8006 SEGMENTTIMER Controller Plate

CONTROLLER PLATE BEHIND FACE

Scoreboard Type: 100

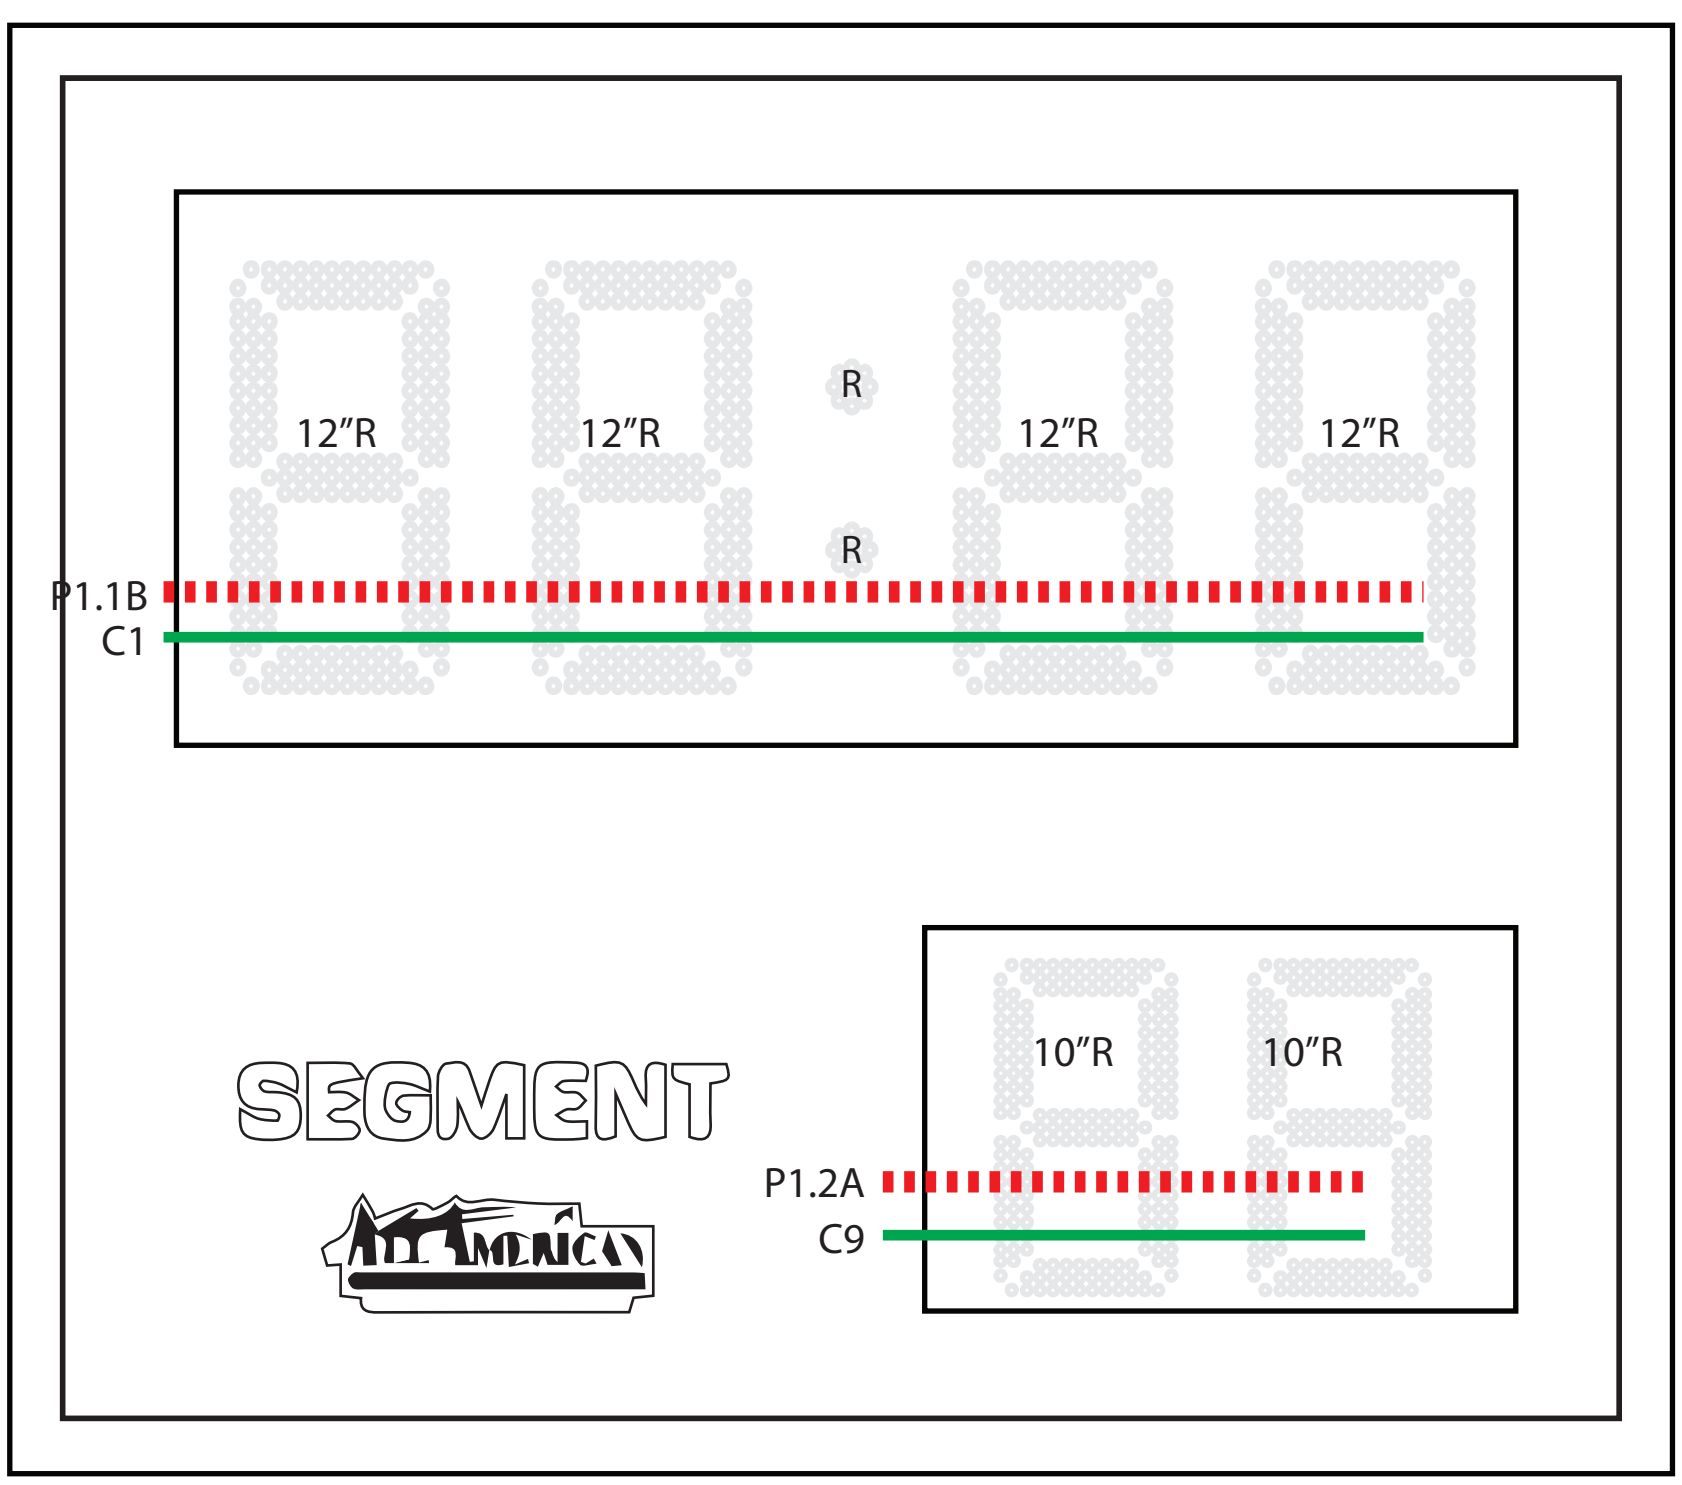
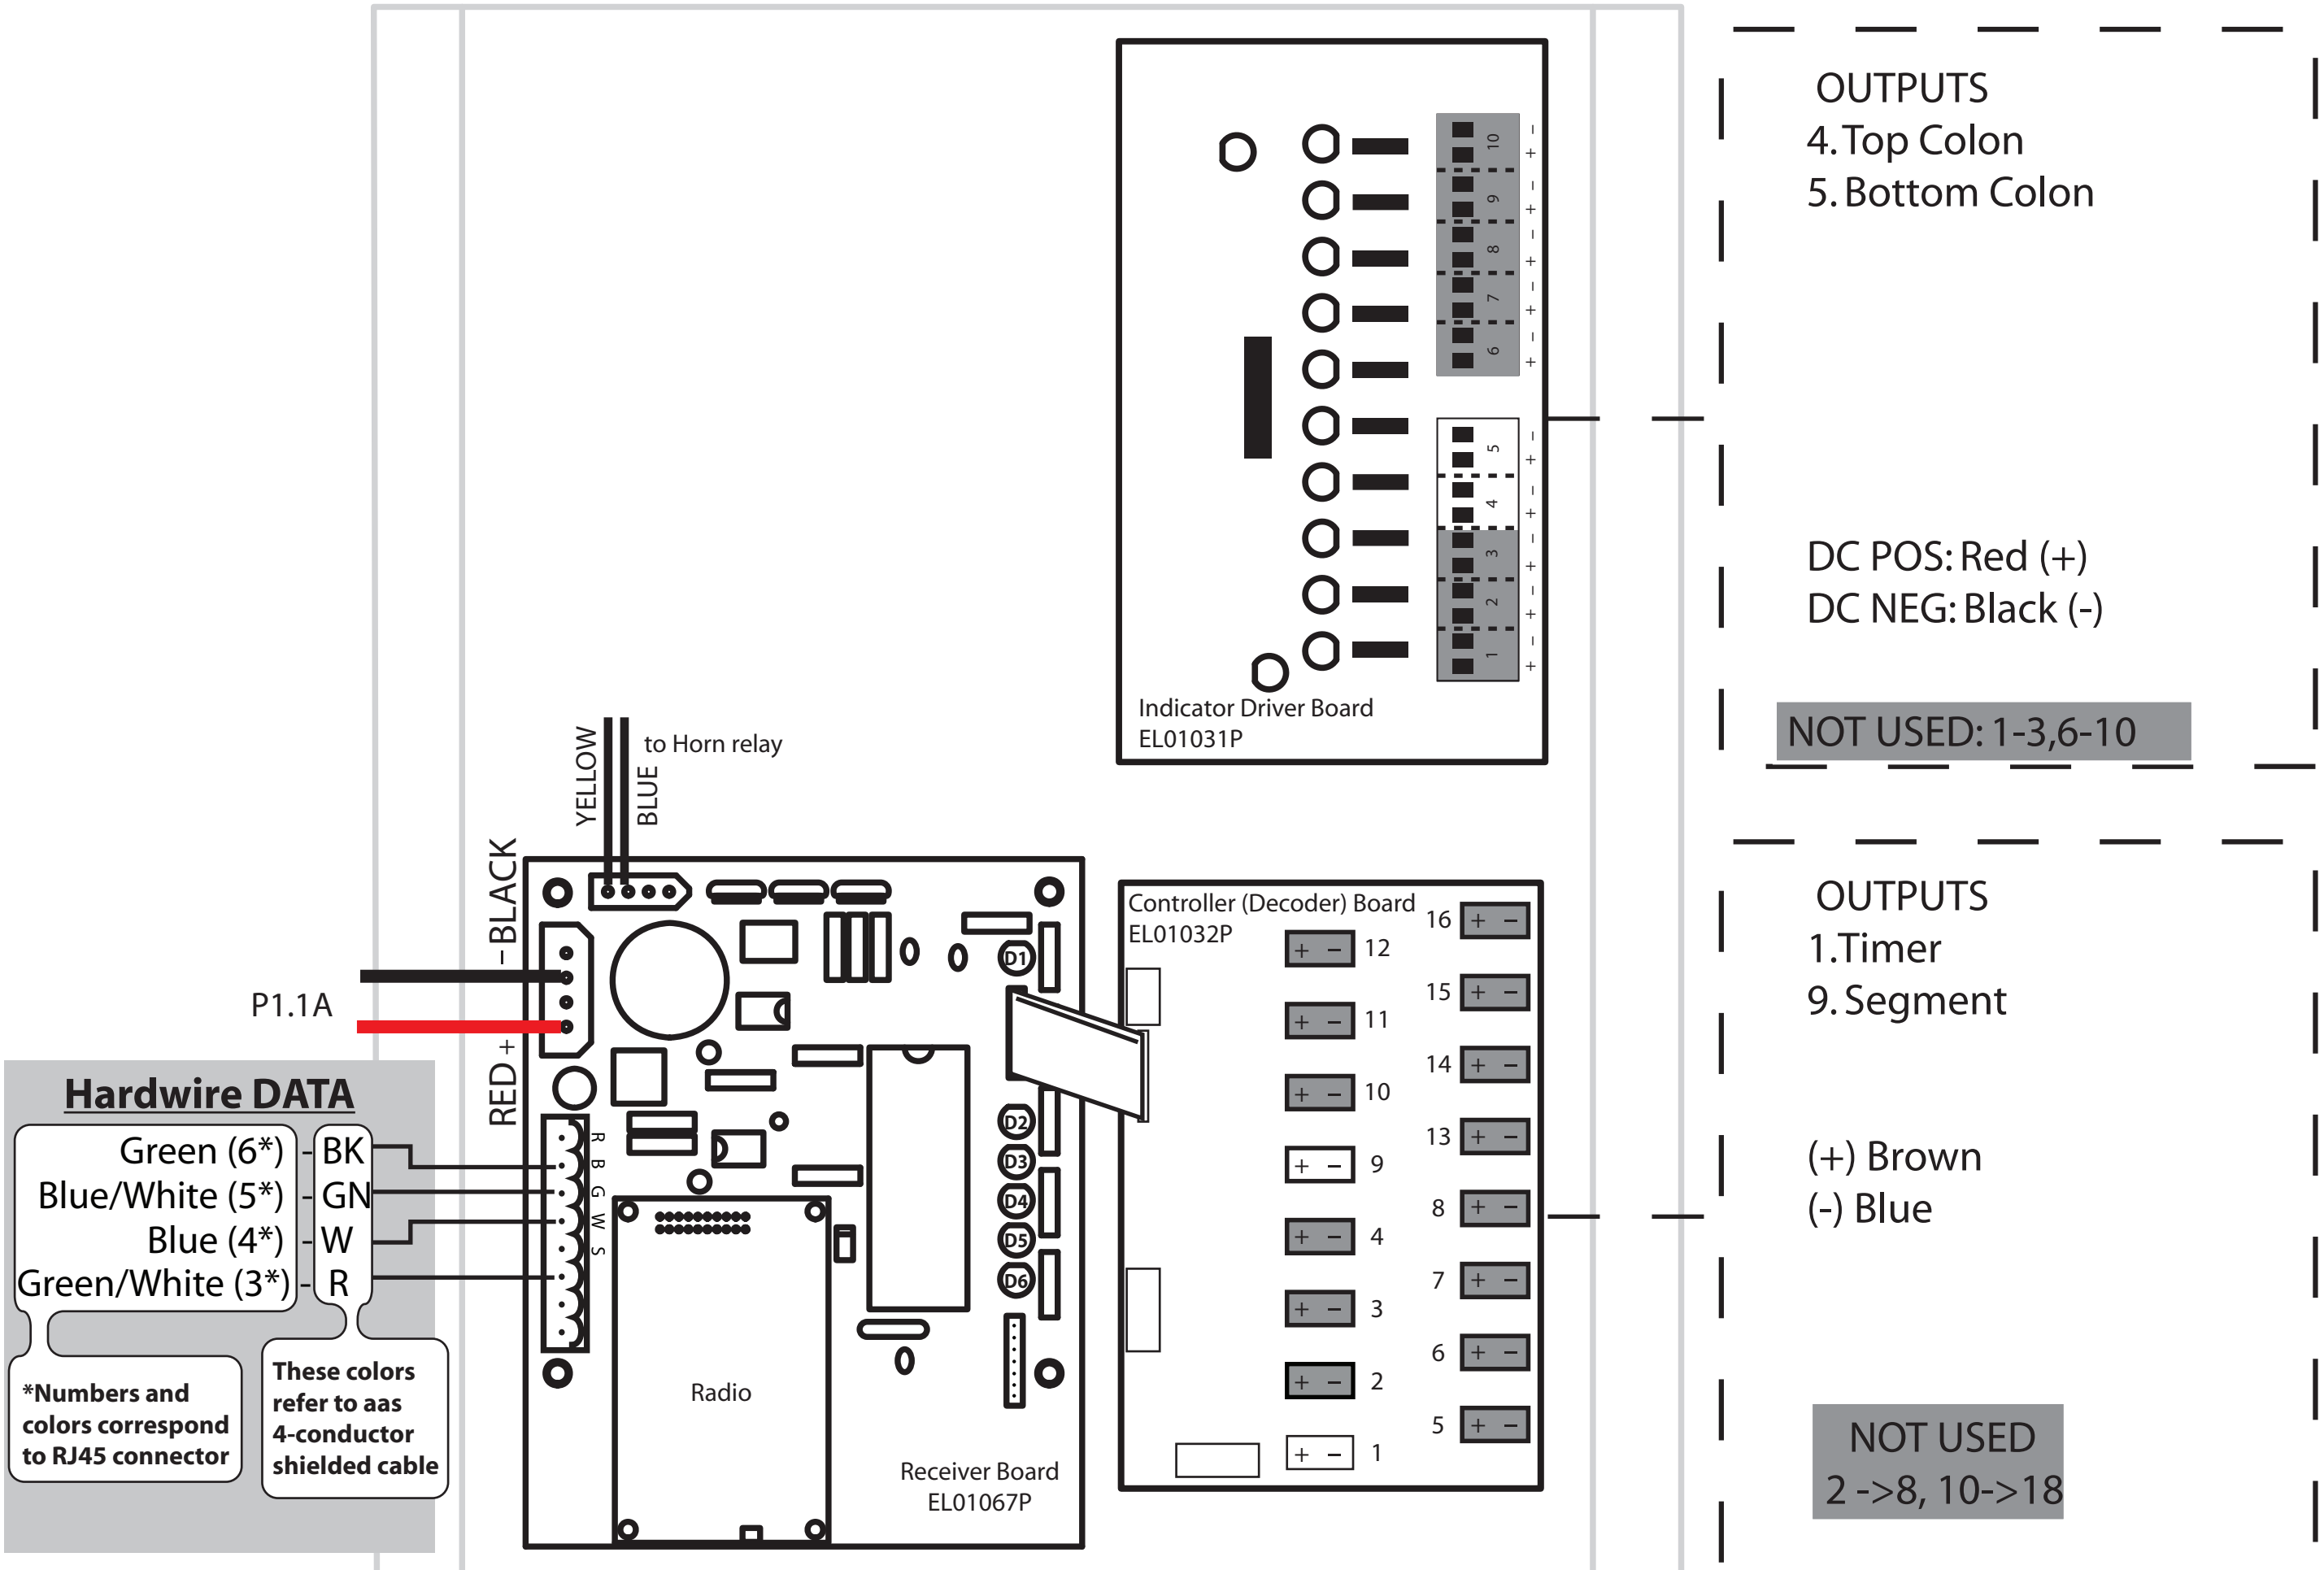
Revised on 6/7/13
Changed from type 400 to type 100 and moved segment output from 2 to 9. This will accomodate both football (timer/dog timer) and segment timing.

No firmware change needed.
